Mayor, City of North Olmsted, Members of Council, Planning Commission and Landmarks Commission

Subj. Biddulph Trail proposal.

Cross Section Looking North

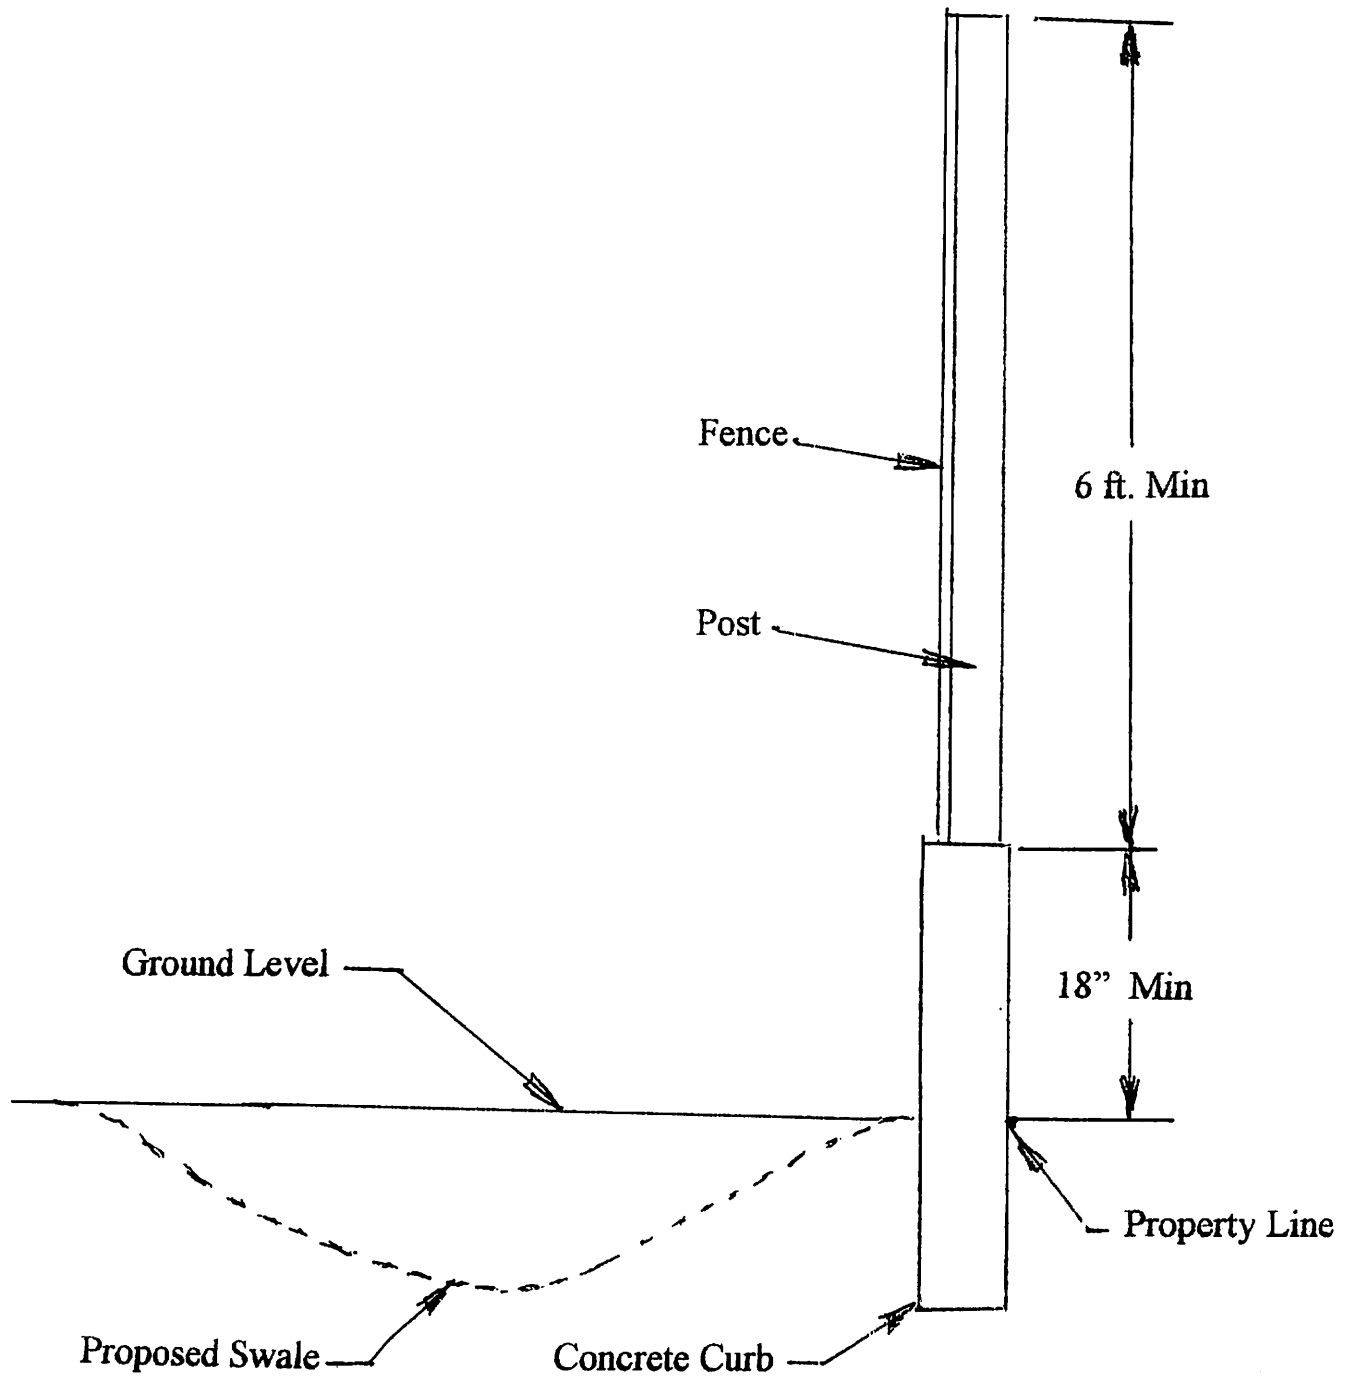
6. The last and most important point that I wish to make is that the swale shown on along the east boundary of the property is inadequate and there is insufficient room for a mound. The city engineer told me that even grass clippings will change a swale over time to say nothing about the effect of leaves and humans. I see no assurance that the proposed homeowners association will keep that open and as designed. And, who will be responsible for

inspections. I think the swale should remain on the design as the first defense. Any water crossing the east boundary of the property north of the sanitary sewer will increase the storm flow through the natural gully which drains my property. This is where the gully passes underneath the sanitary where it is on fill dirt. That homeowner, the former city engineer, diligently watches the culvert there to assure it is kept open because if it is blocked, the underpinnings of the sanitary are lost and could collapse with disastrous consequences. There is a possible back up to the swale which I have described on an enclosed cross section sketch and with photographs. A curb could be built along the east boundary about 18 inches high that would be a backup to the swale. This backup would prevent water crossing the east boundary and take that water south of the sanitary and out of the picture and should be incorporated. I would also request a privacy and security fence above the curb and my neighbors to the south will request it be extended past their property as well. See attached illustration with photos of three similar installations in North Olmsted and one in Strongsville.

Before any work is begun on the site it is imperative that **all** runoff water be channeled to the south and into the existing large ditch that feeds through a large culvert that crosses under SR 252.
